PLATTE SELF STORAGE WATER & UTILITY SERVICE PLAN COVER SHEET MAY 2024

PLATTE SELF STORAGE

GRADING AND EROSION CONTROL PLAN

PLATTE SELF STORAGE
GRADING AND EROSION CONTROL PLAN
INITIAL - NORTH SIDE

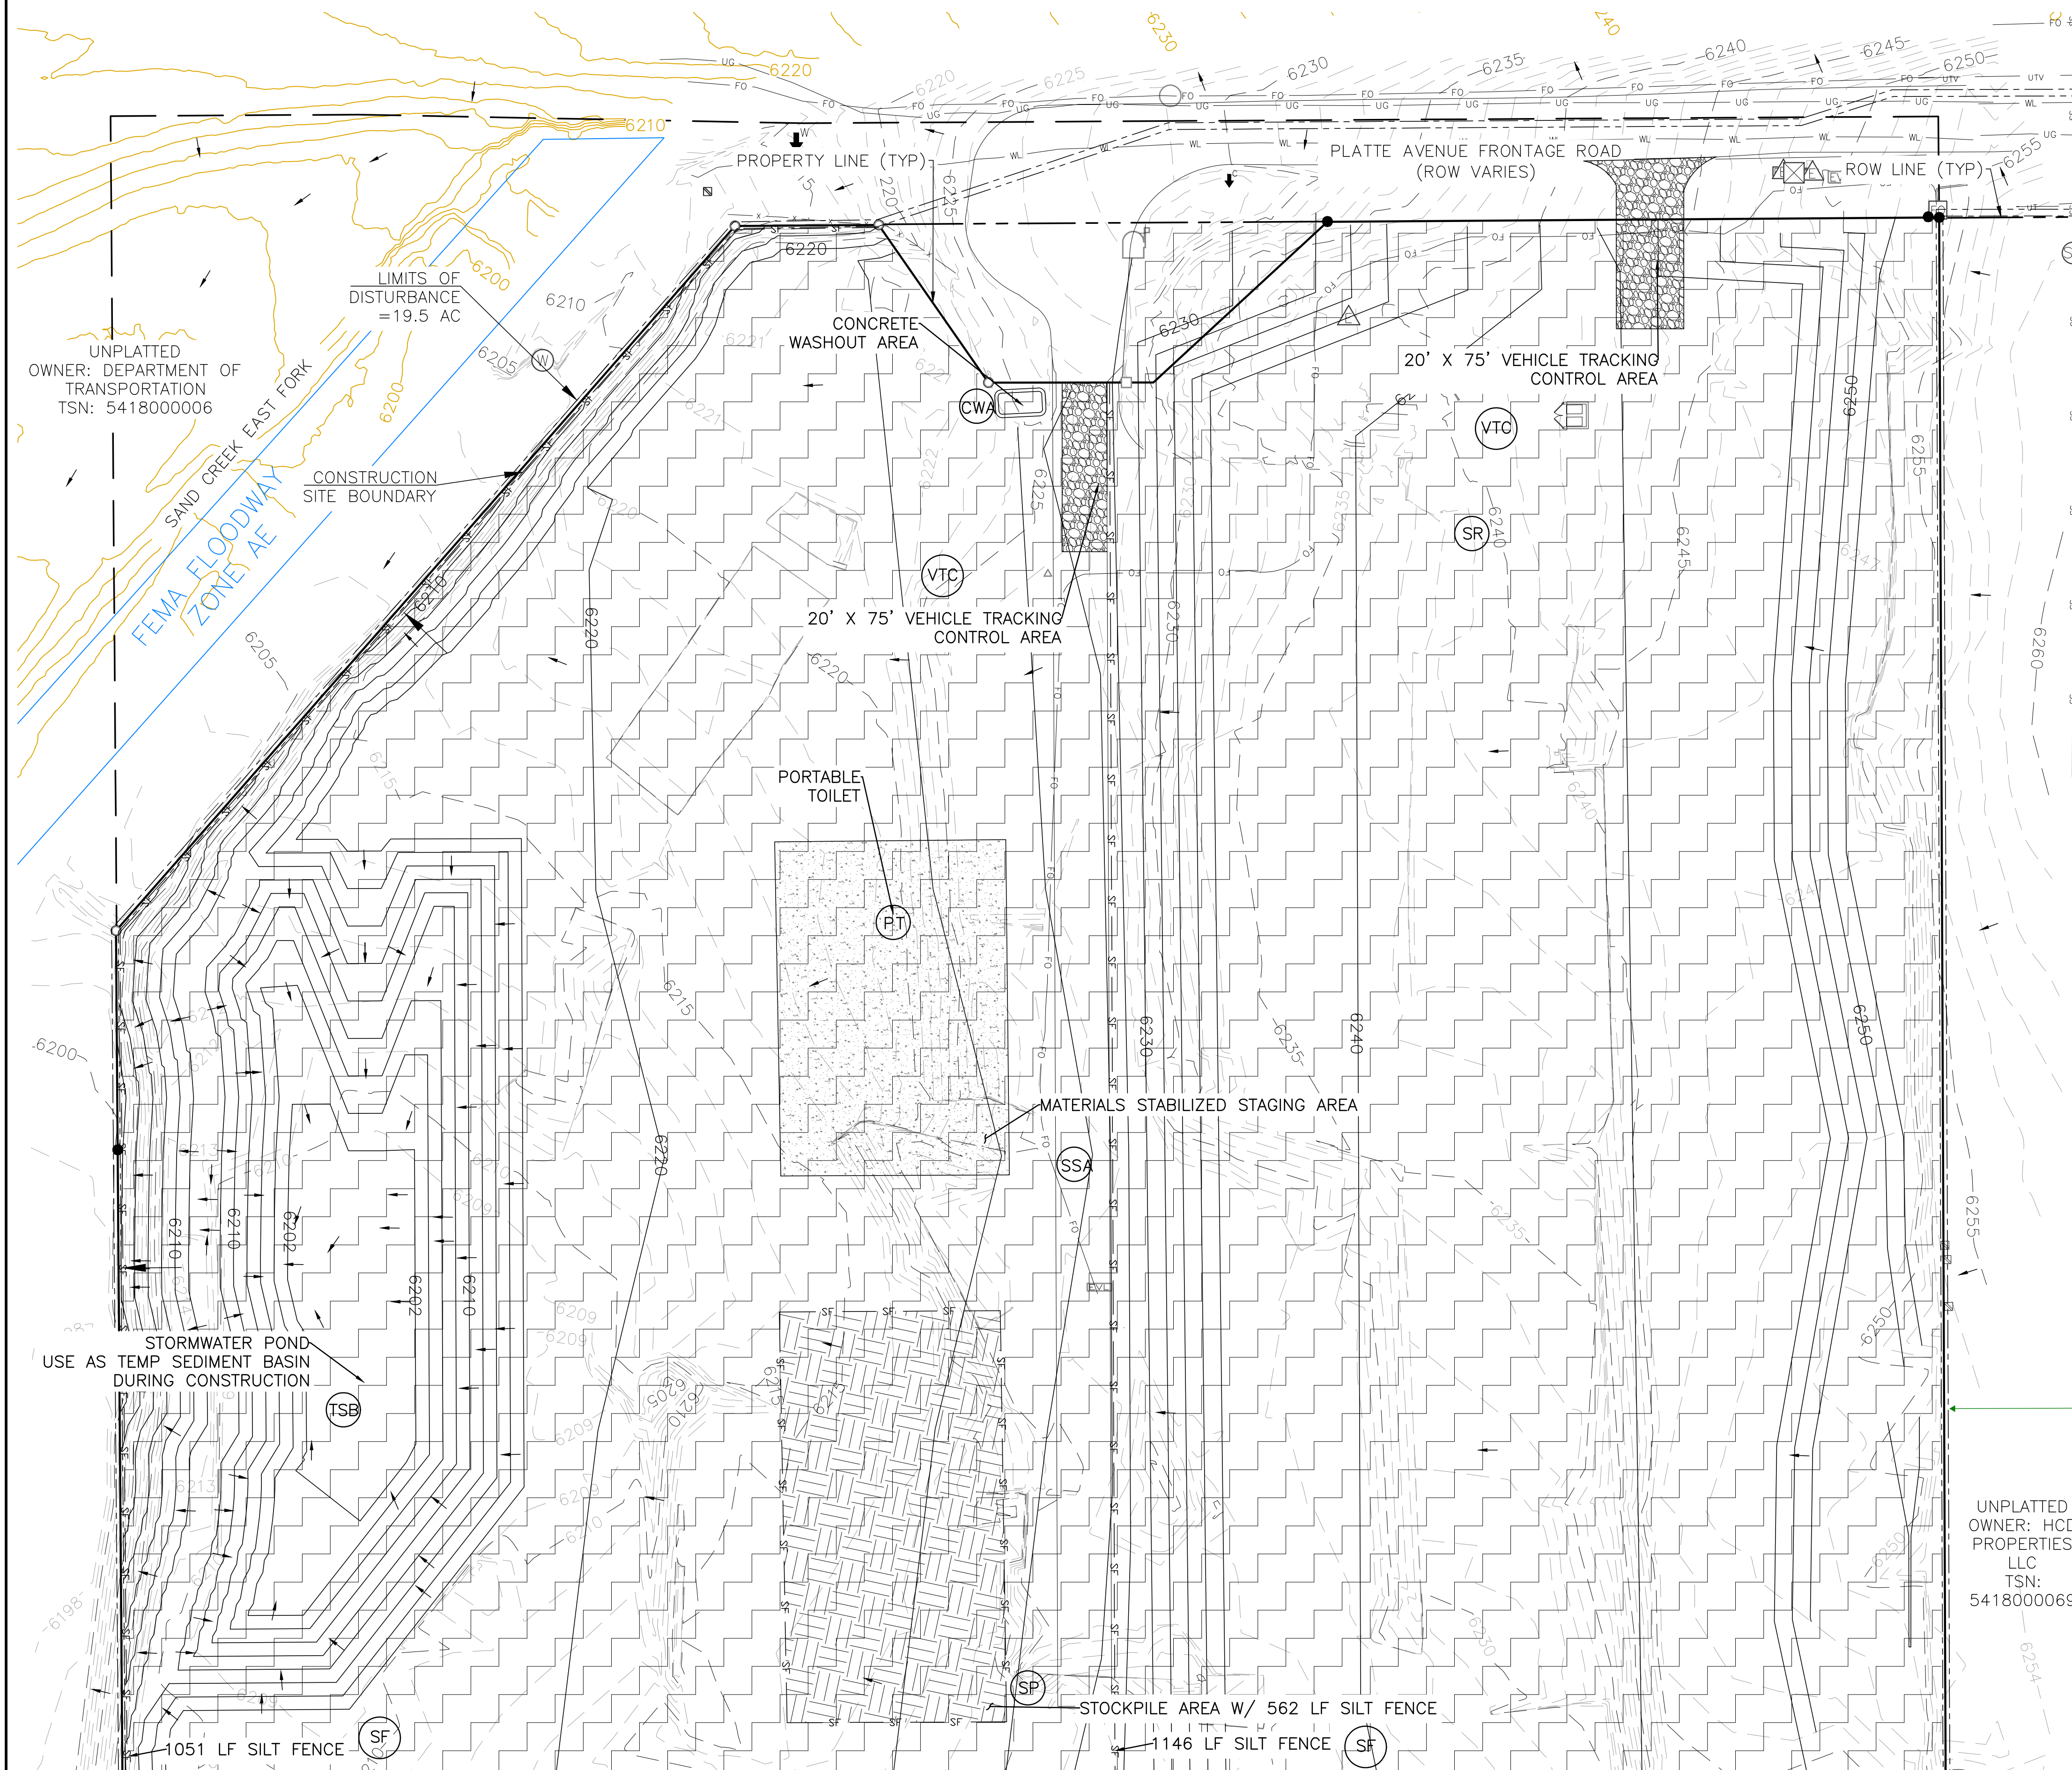
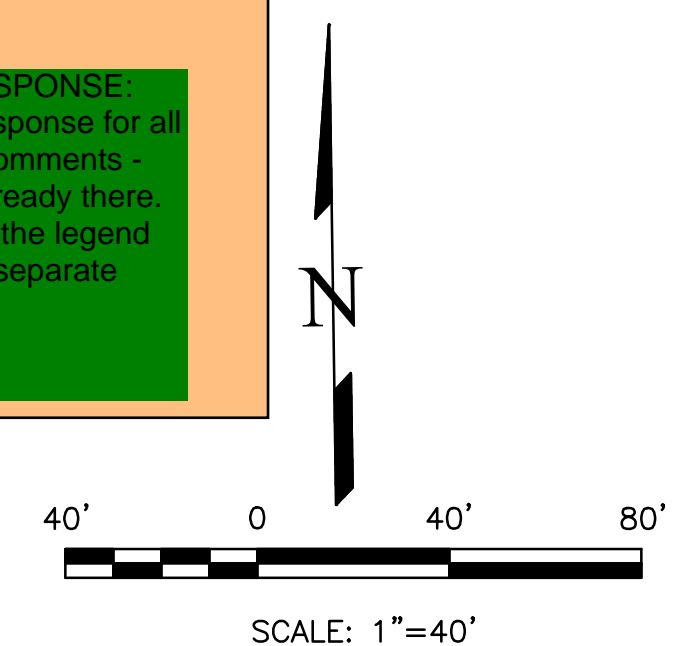
Typical comment for all EC sheets: Add construction boundaries and limits of disturbance.

OWNER'S RESPONSE:
Typical response for all of these comments - They're already there. They're in the legend and have separate callouts.

PLATTE SELF STORAGE
GRADING AND EROSION CONTROL PLAN
INTERIM EROSION CONTROL PLAN - NORTH SIDE

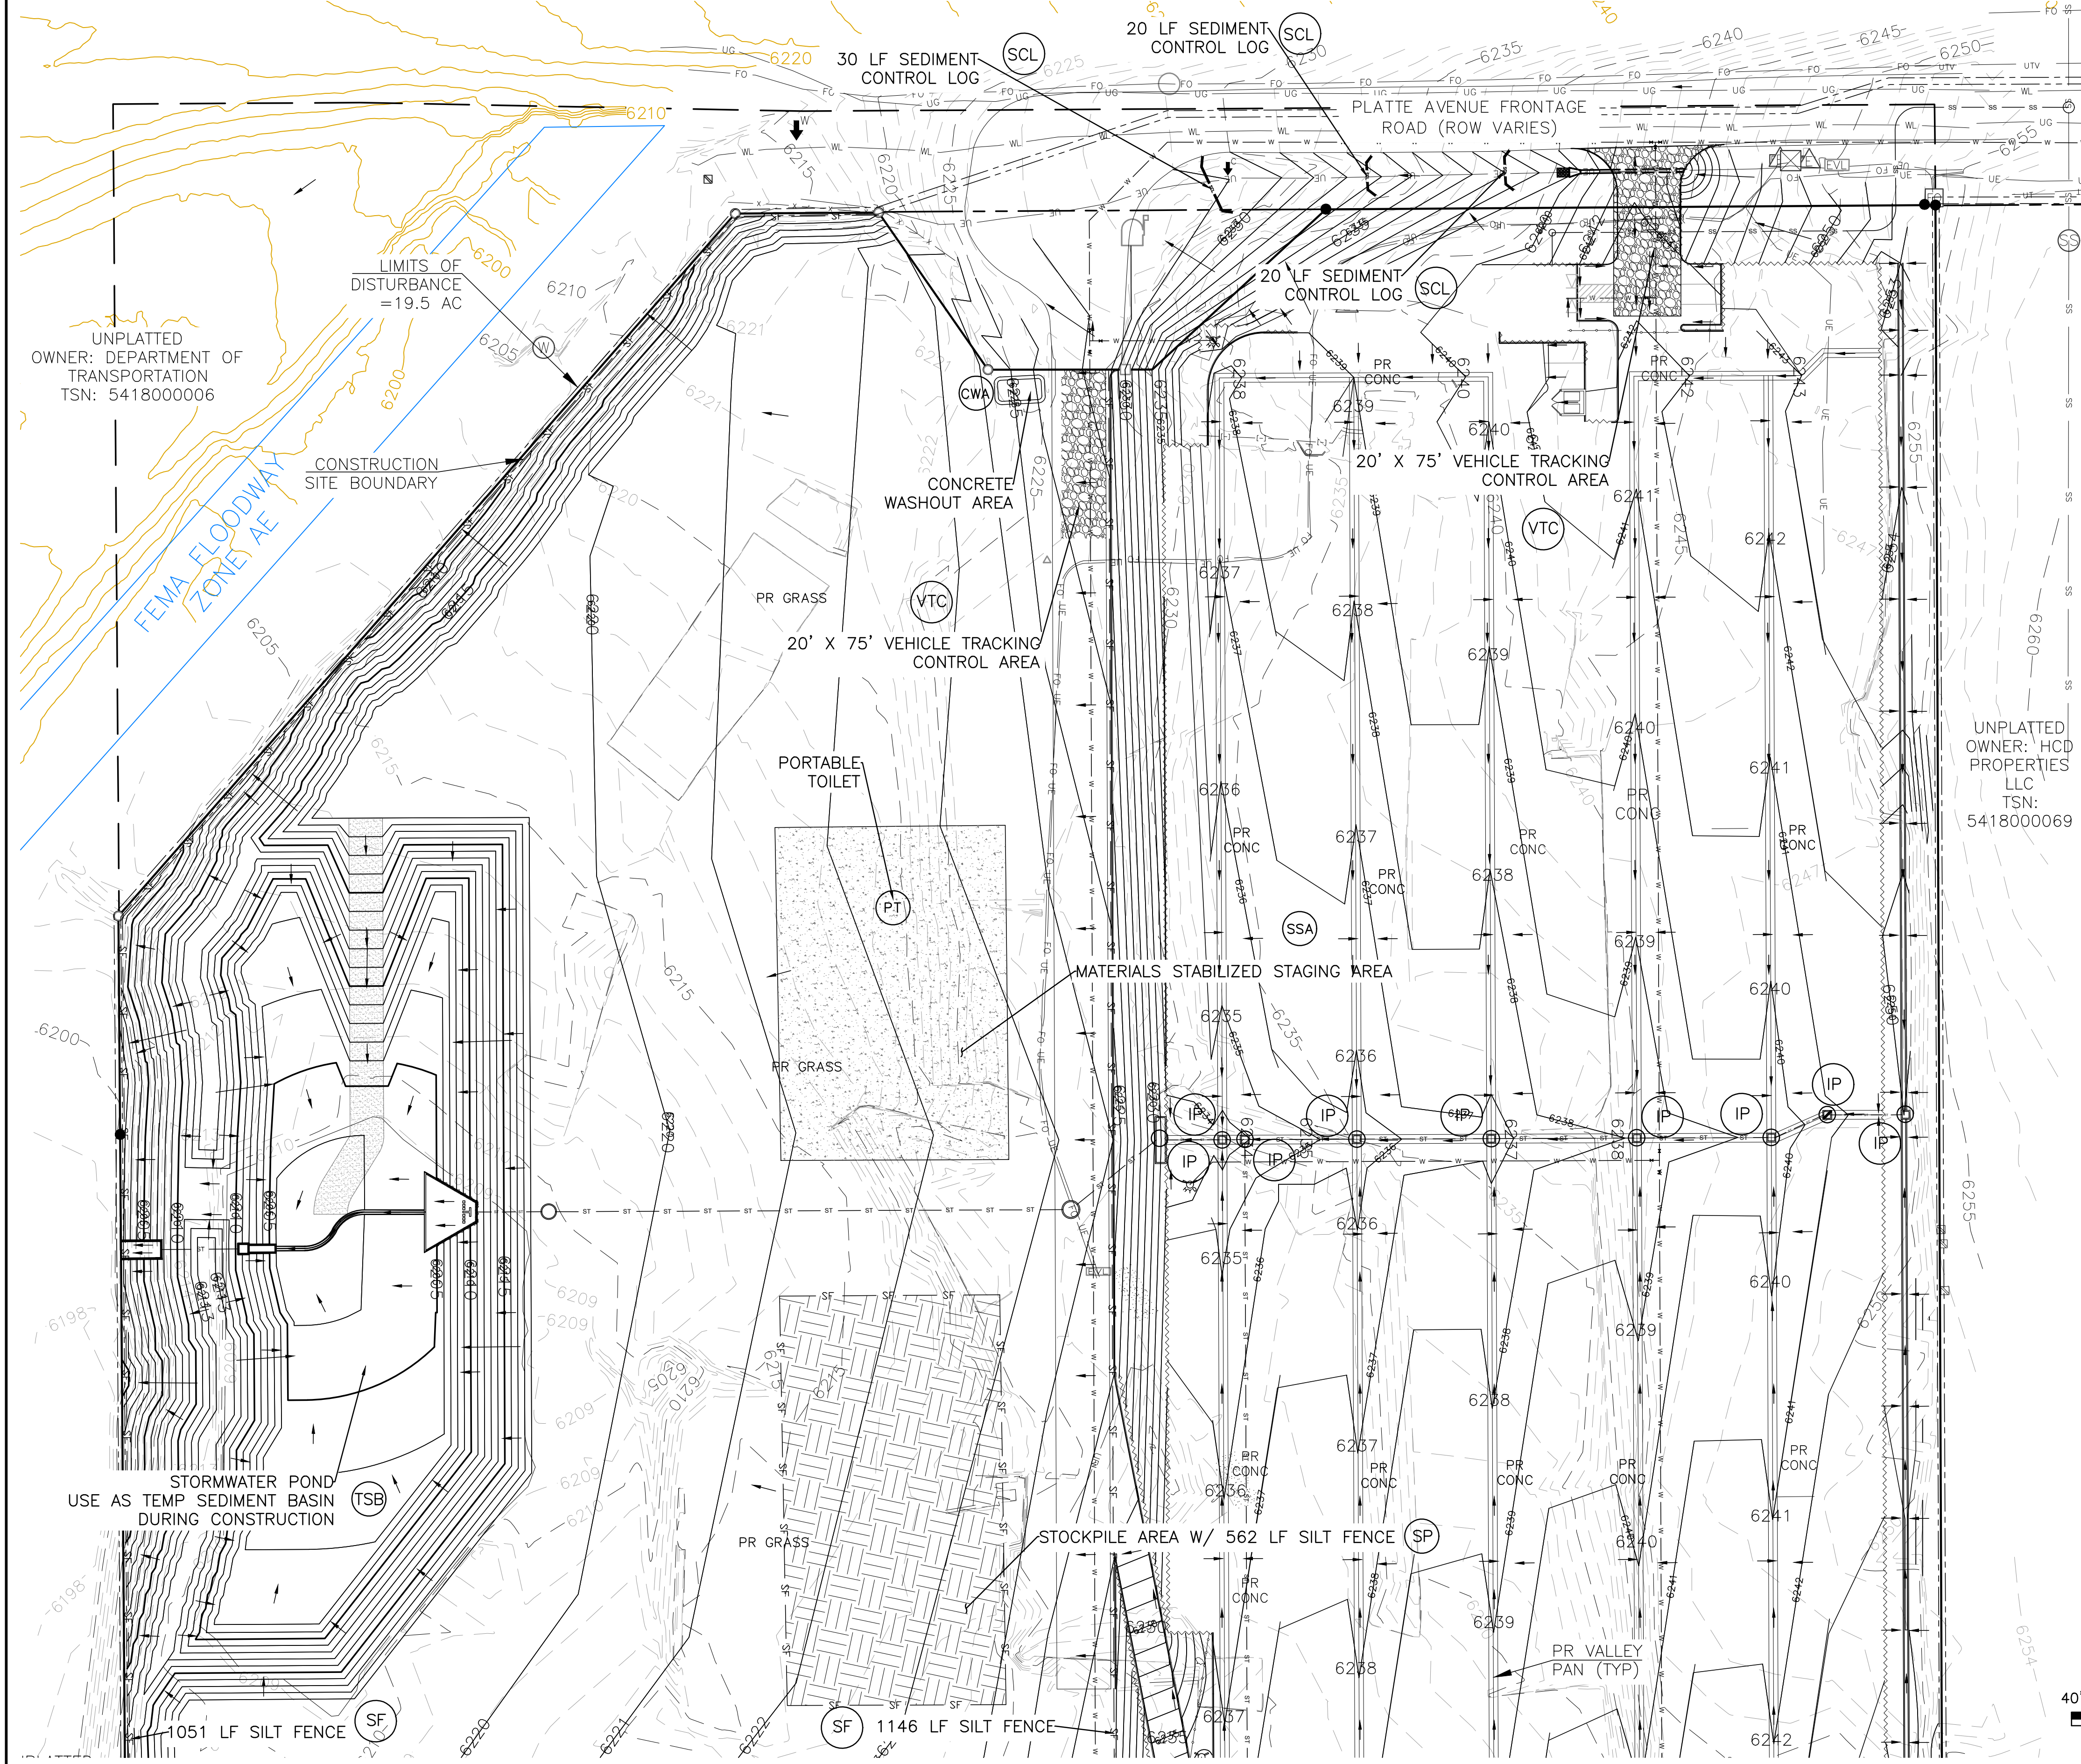
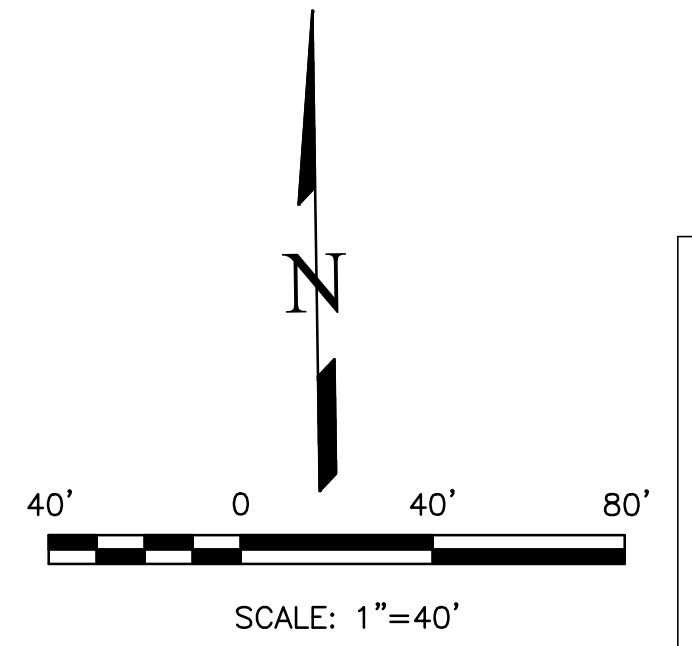
We need initial as well. Put the initial EC prior to this sheet. It is before the grading currently.

Show cut/fill limits

TNES RESPONSE: Moved.

TNES RESPONSE: Added.
